CIRCUIT COMPARISON

ChryslerScanner

Original schematic -> current circuit sets

Original: Daniel Laszlo, revision 2.4.0-1, 2026-01-05. Current: Rev C, 24 pages / 329 circuit-probe endpoints.

15 SCI RX7 and RX15 paths

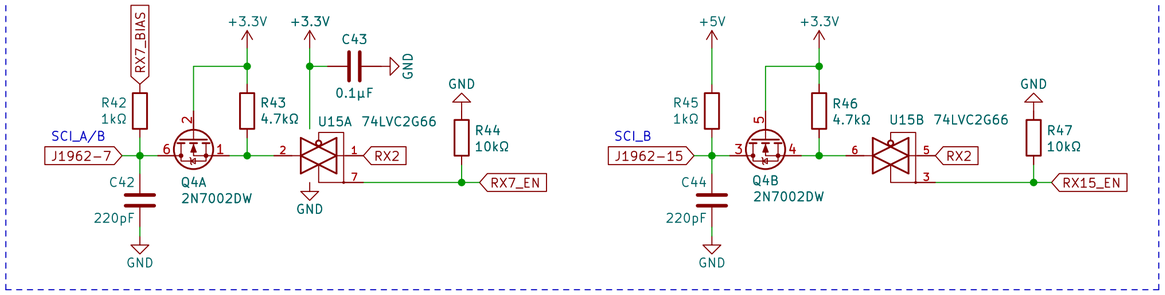
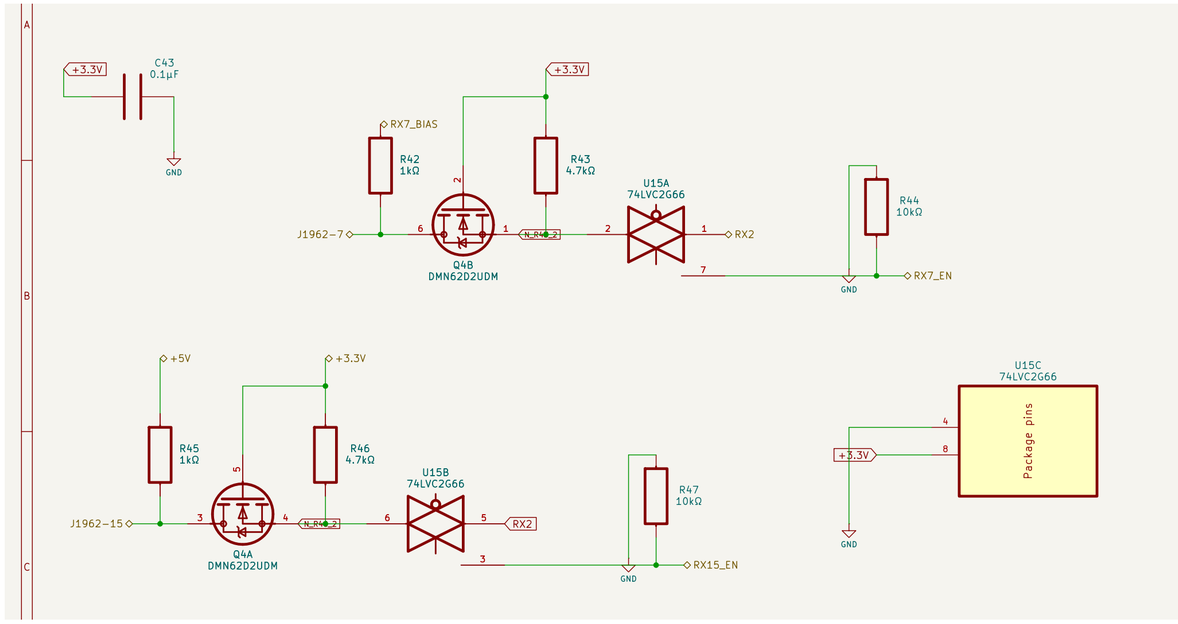
- The Q4/U15 sections, R42-R47, C43 and RX2 receive function correspond to the original.
- C42 and C44 have moved to the grouped connector/protection drawing; they are not missing from the receive networks.

16 Battery, VBB and VPP monitoring dividers

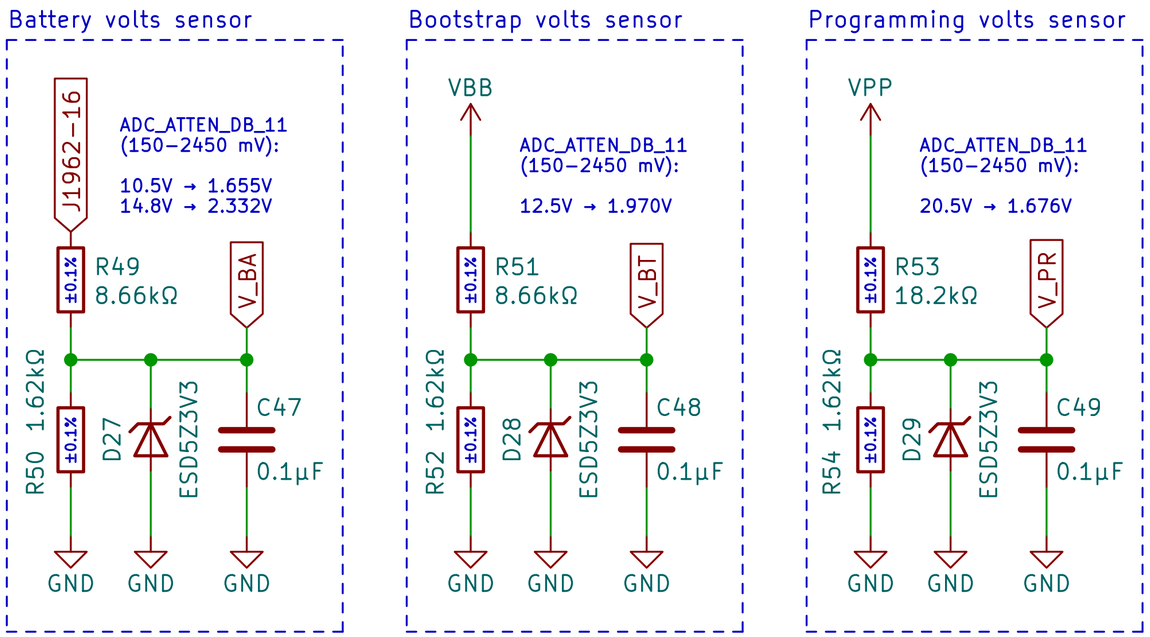
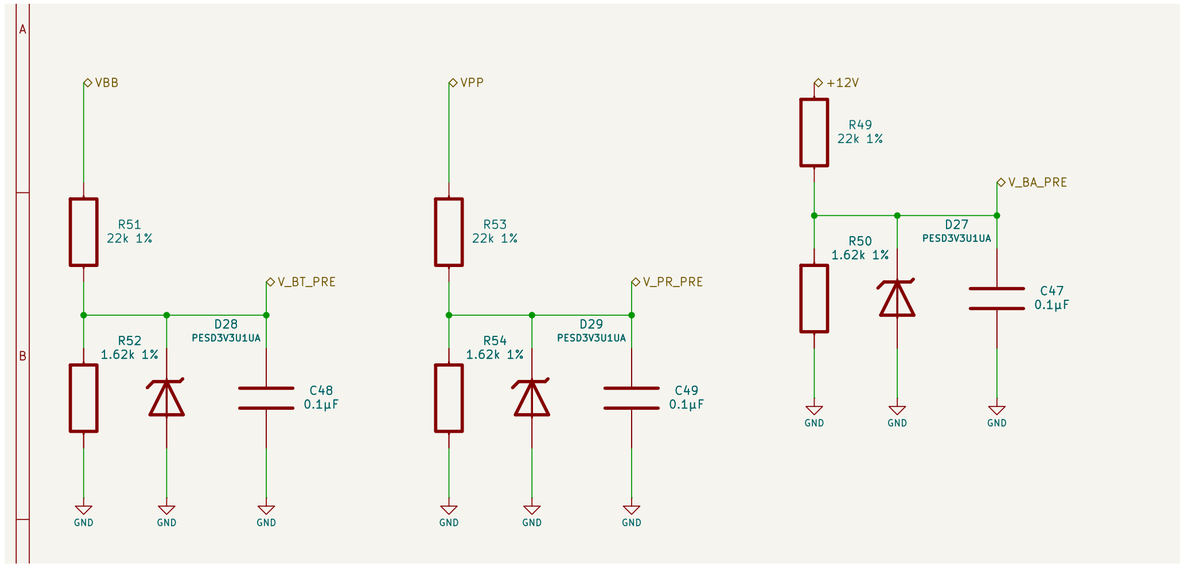
- R49/R51/R53 are now 22k 1%; R50/R52/R54 are 1.62k 1%. R49 input moves to protected +12V.
- The divider outputs are now V_BA_PRE, V_BT_PRE and V_PR_PRE. U21 isolation on the safety page creates the final ADC nets; calibration must reflect these intentional changes.

17 CCD termination, bias and input filtering

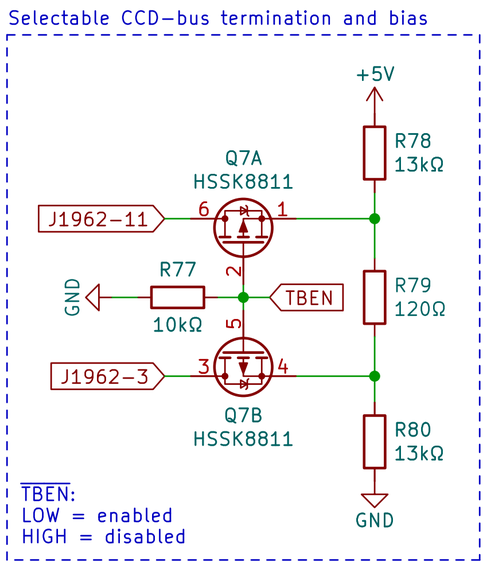
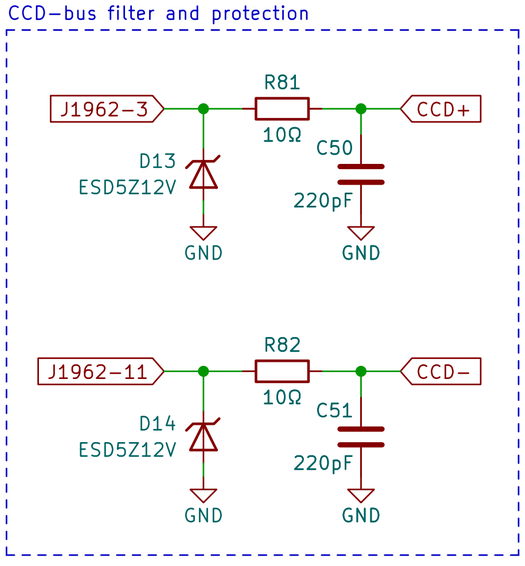
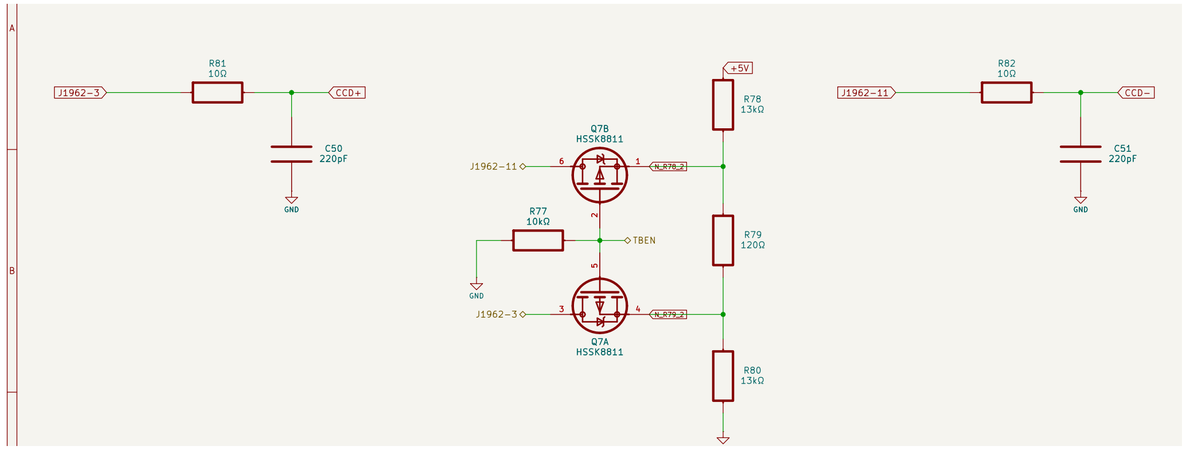
- Q7, R77-R82 and C50/C51 retain the original termination, bias and filter functions.
- D13/D14 are grouped on the input-protection page. The vehicle input nets and internal CCD+ / CCD- nets remain distinct as drawn.

18 CCD receiver

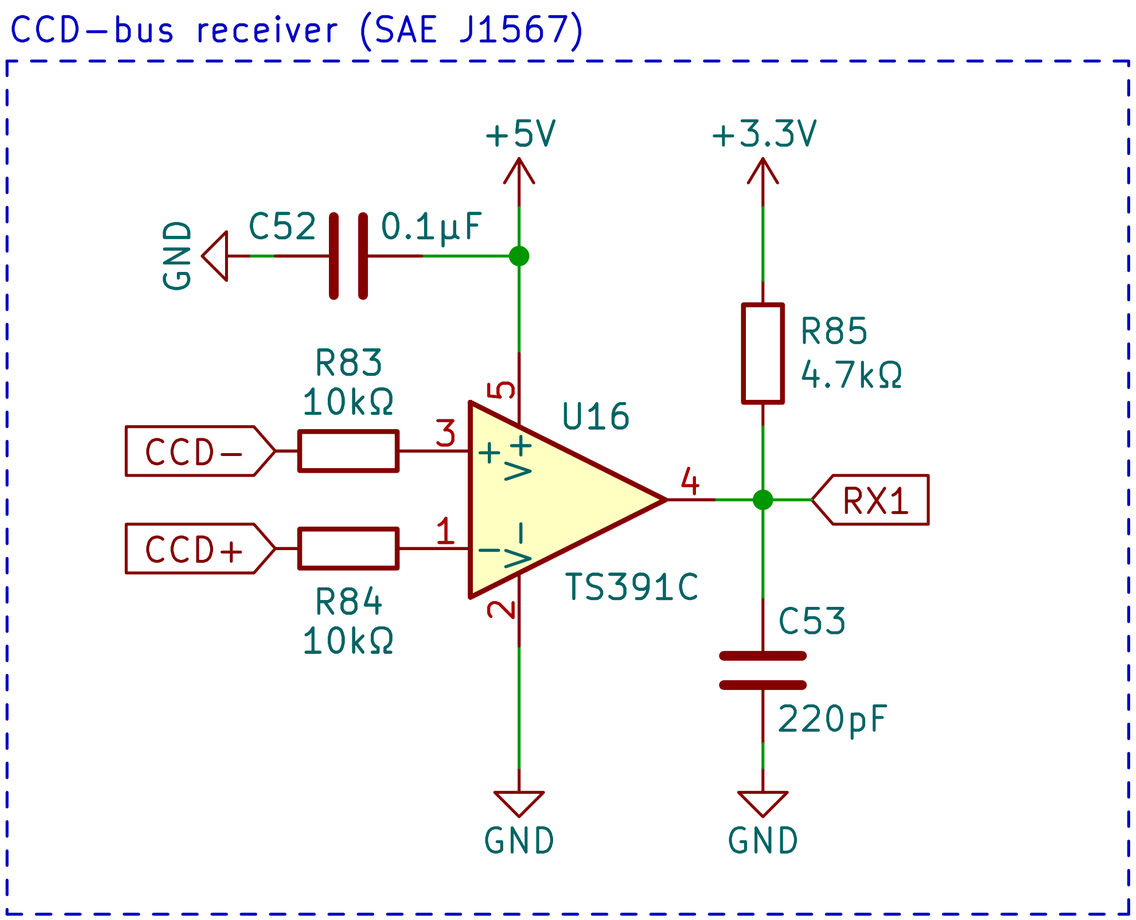
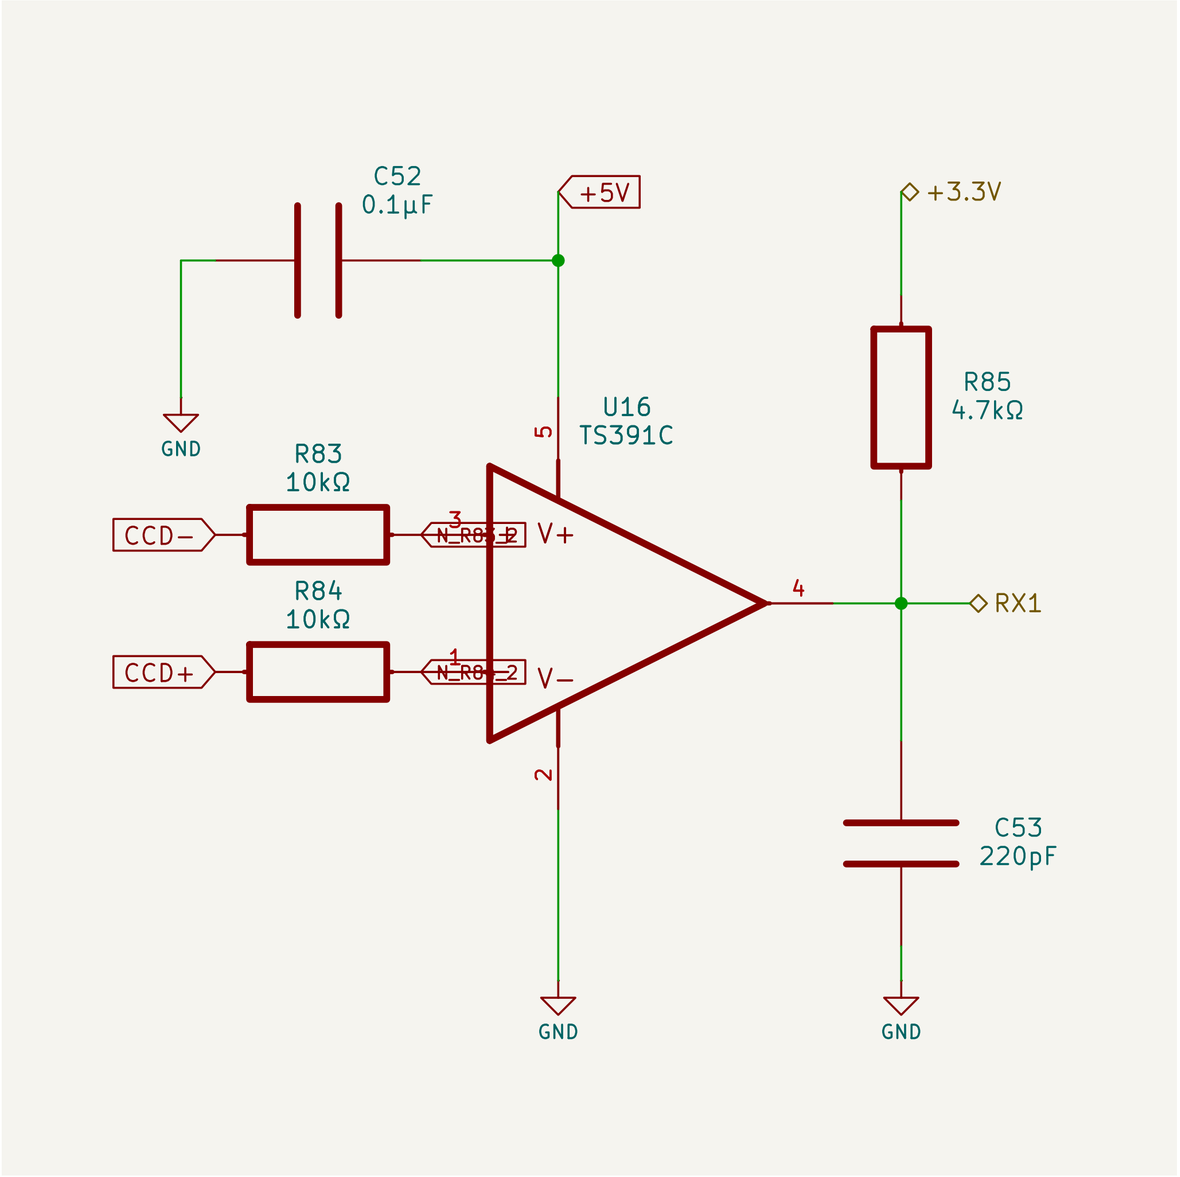
- U16 TS391C, R83-R85 and C52/C53 correspond to the original CCD-to-RX1 receiver.
- The receive logic net is RX1; identify the comparator by reference and net labels, independently of the new sheet position.

19 CCD transmitter

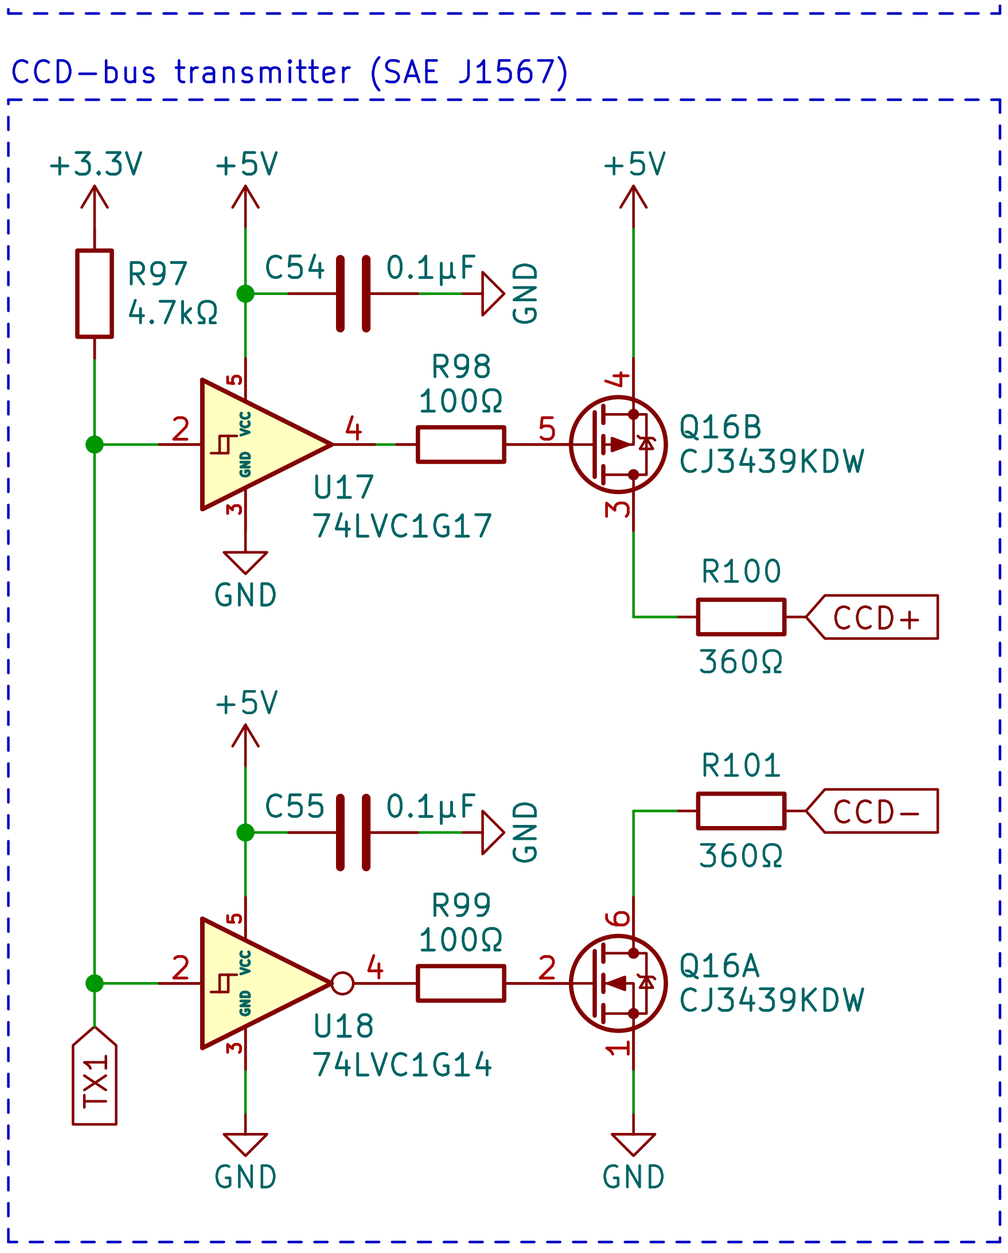
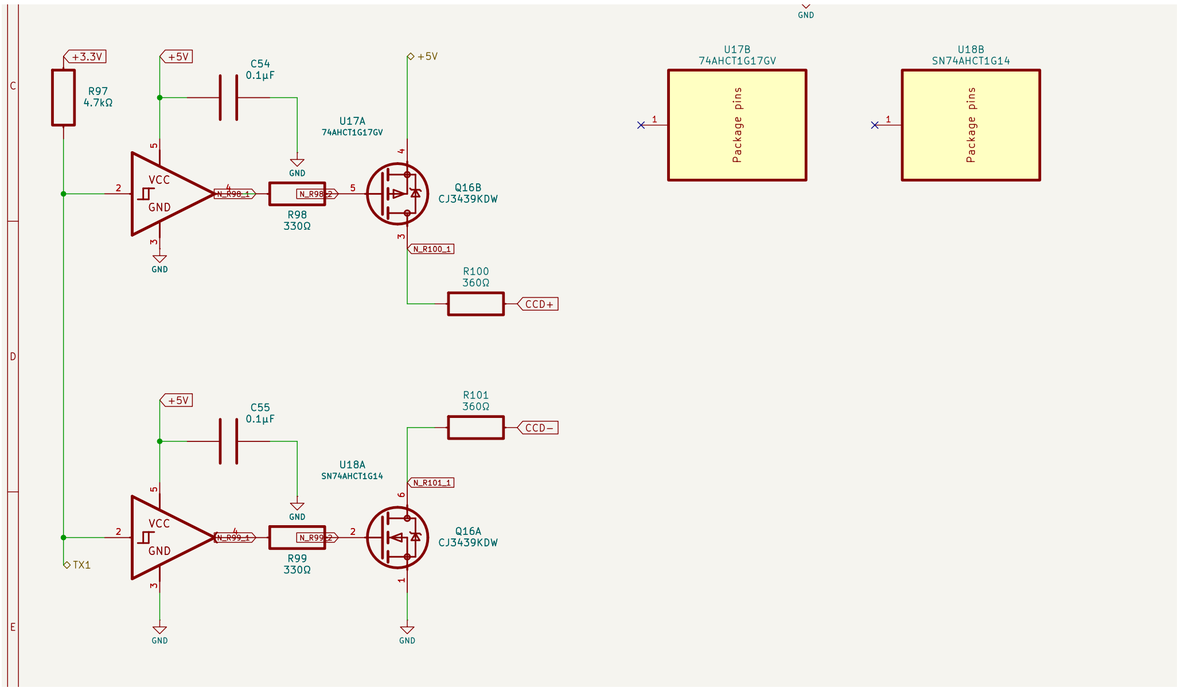
- U17/U18, both Q16 sections, R97-R101 and C54/C55 correspond to the original TX1 drive circuitry.
- Extra displayed gate units belong to the same existing IC packages and do not add a new transmitter capability.

20 SCI pin 6: VBB / VPP programming switches

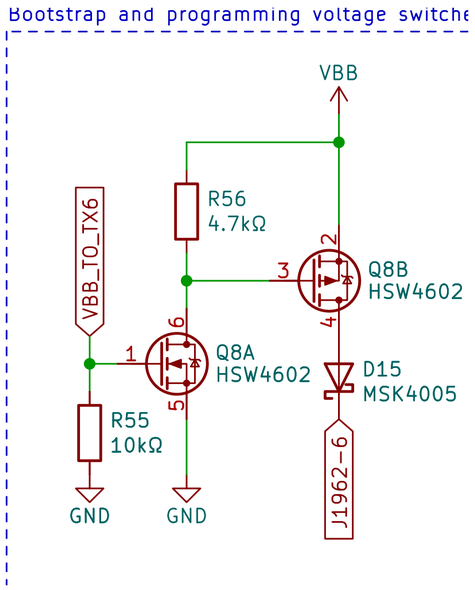
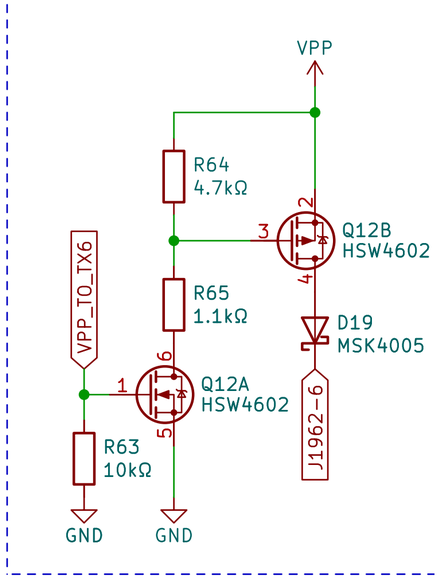
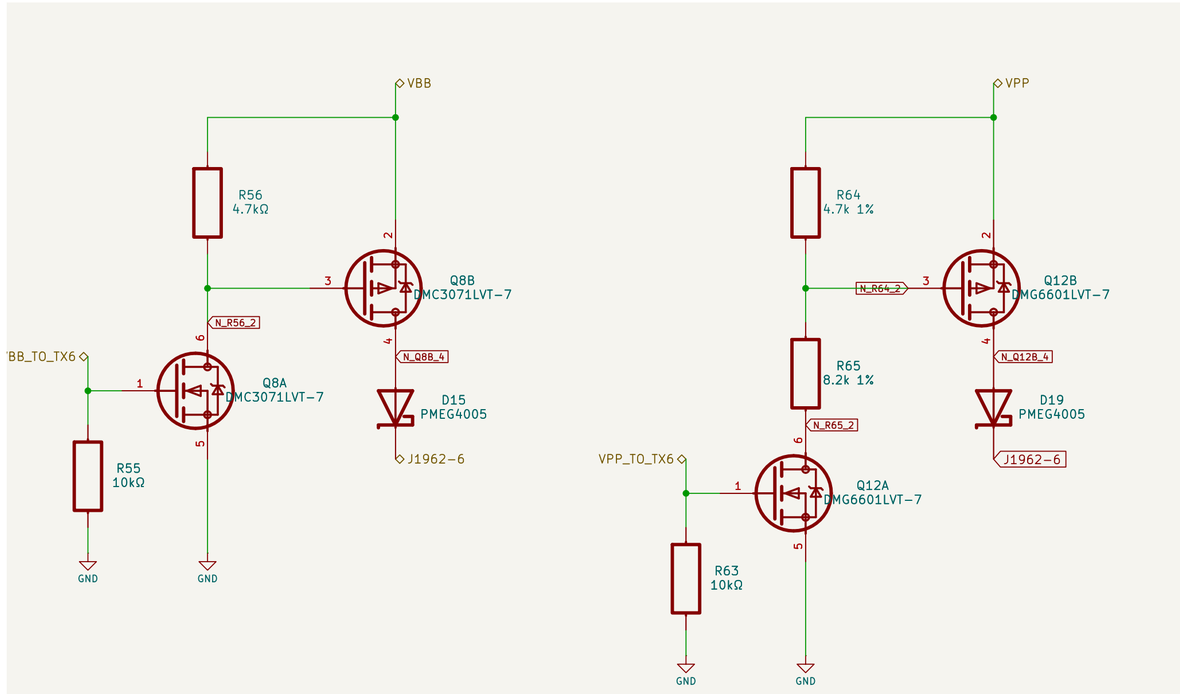
- The two rail-switching branches are paired by vehicle pin on a dedicated page.
- Q8-Q11 and Q12-Q15 use revised FET families. The VPP gate-divider values are intentionally revised to 4.7k / 8.2k; compare current labels rather than assuming identical parts.

21 SCI pin 9: VBB / VPP programming switches

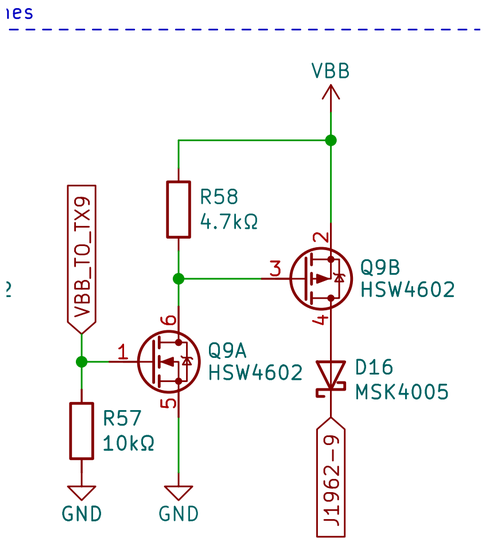
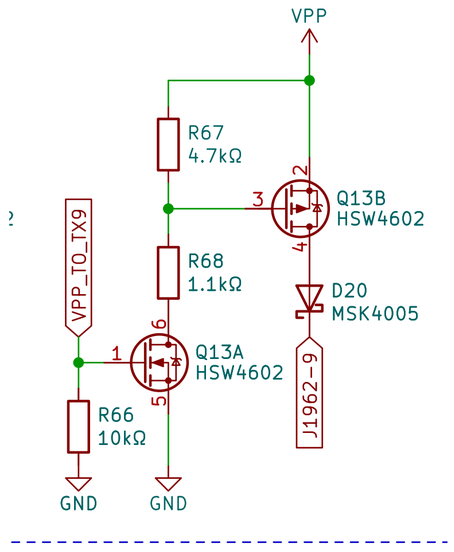
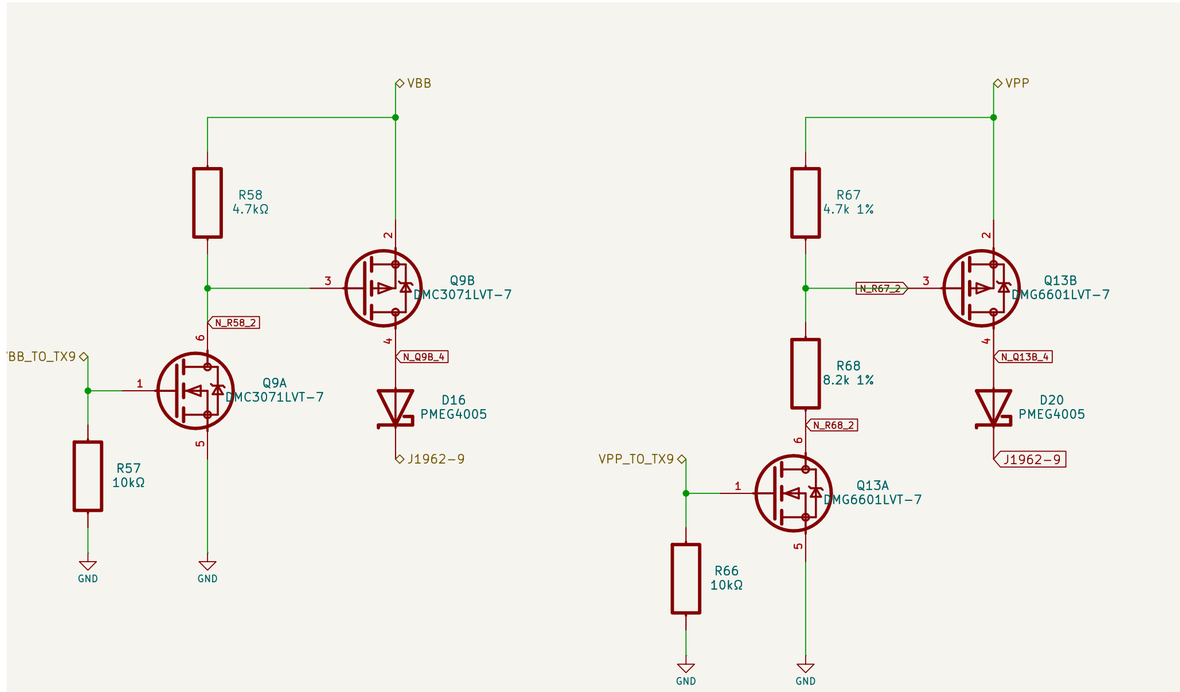
- The two rail-switching branches are paired by vehicle pin on a dedicated page.
- Q8-Q11 and Q12-Q15 use revised FET families. The VPP gate-divider values are intentionally revised to 4.7k / 8.2k; compare current labels rather than assuming identical parts.
